October 3, 2022

TCMC EMERGENCY DEPARTMENT

POST-BID ADDENDUM NO. 4

SHEET NUMBER:
E206

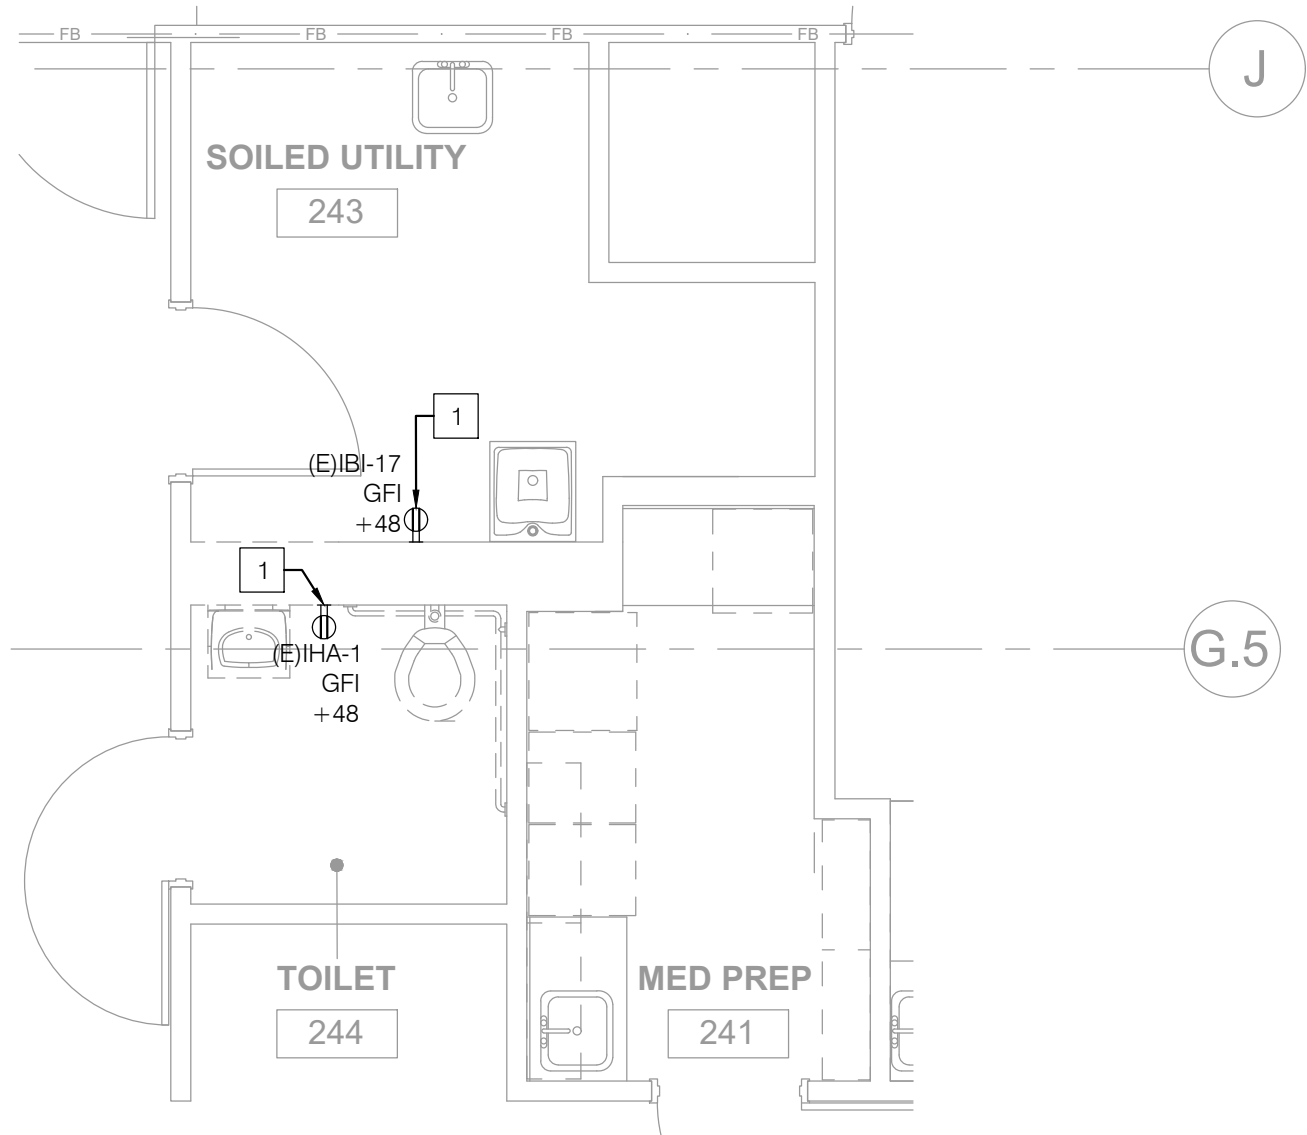
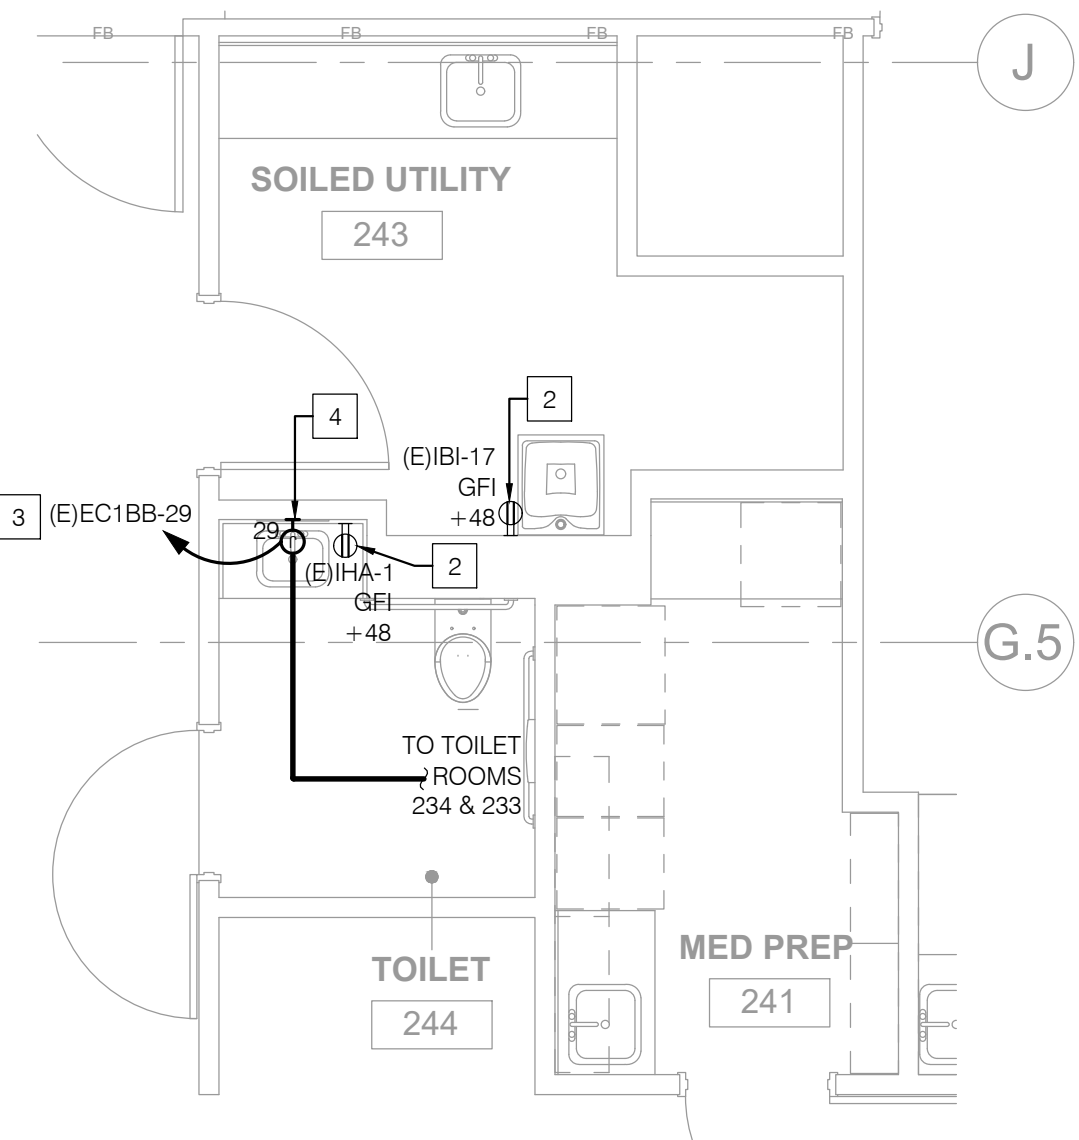
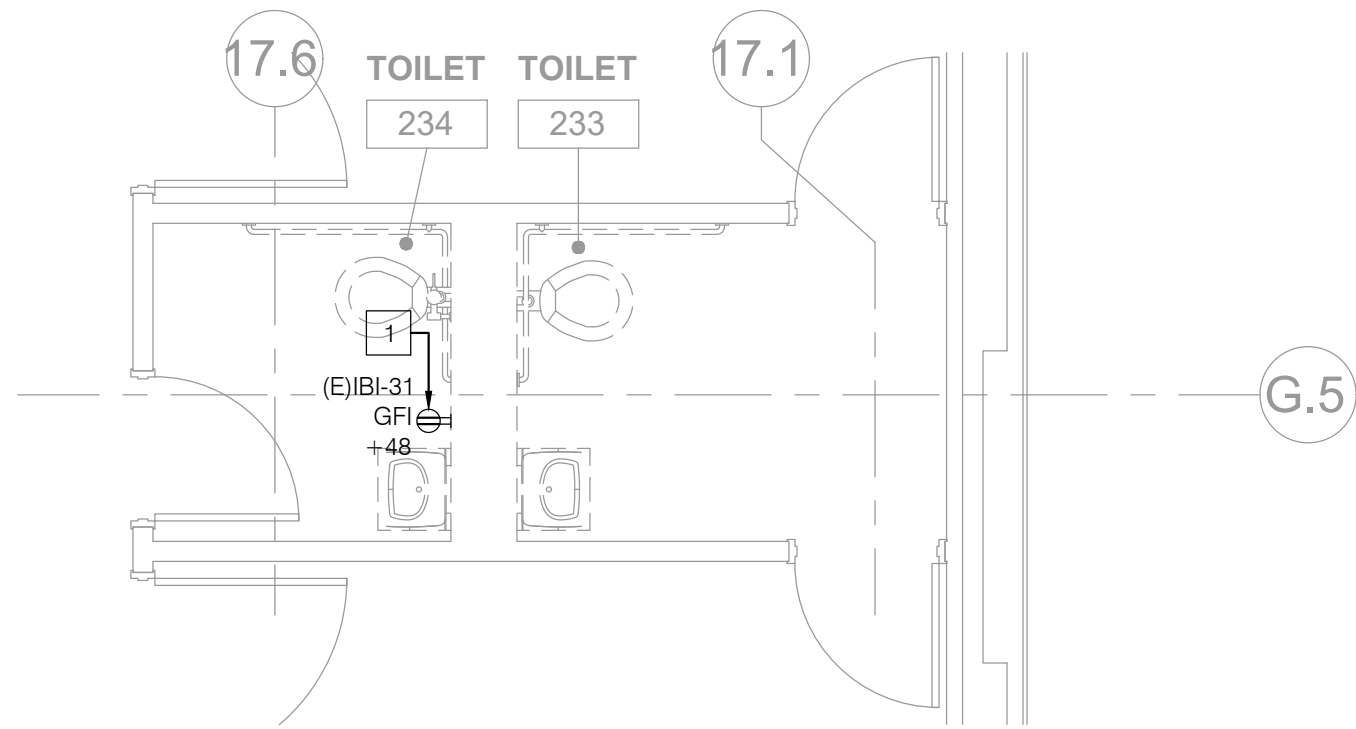
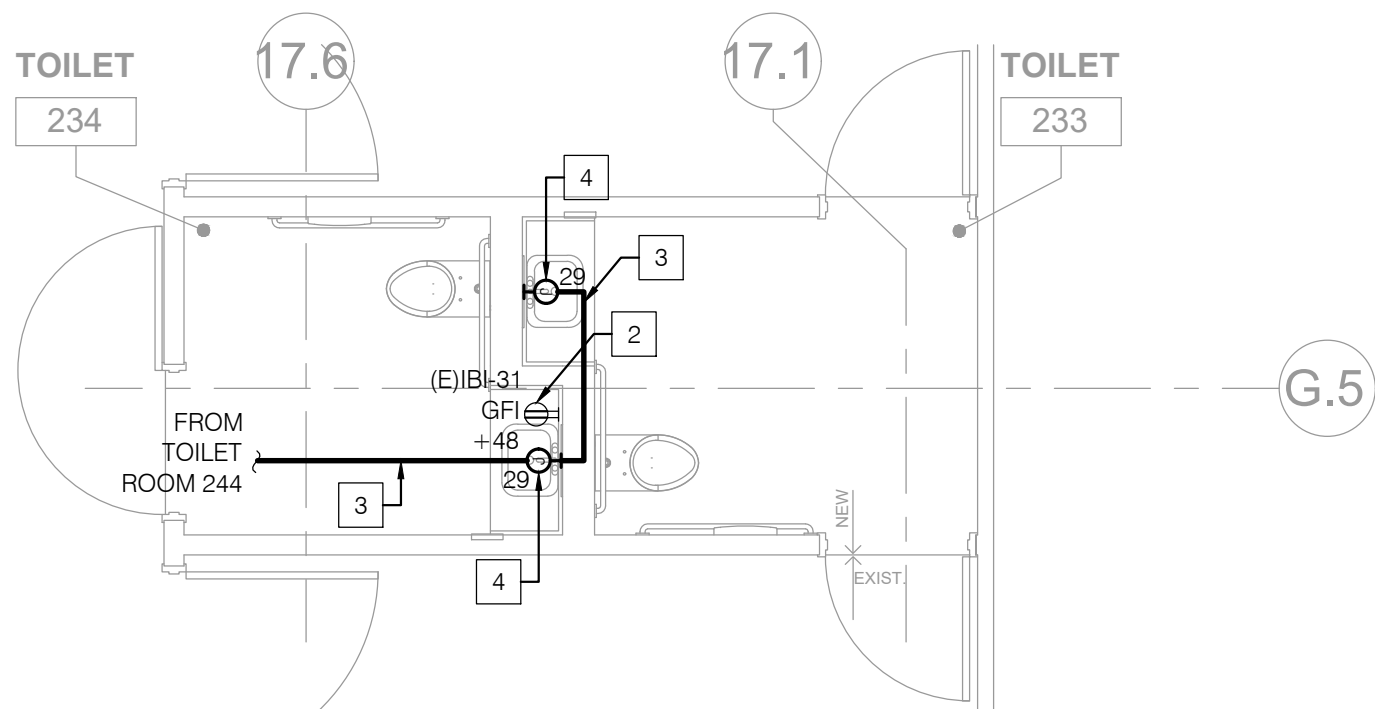
See attached revised drawings with delta 5 dated 9/23/22:
E201, E204, E206, T001, P002.
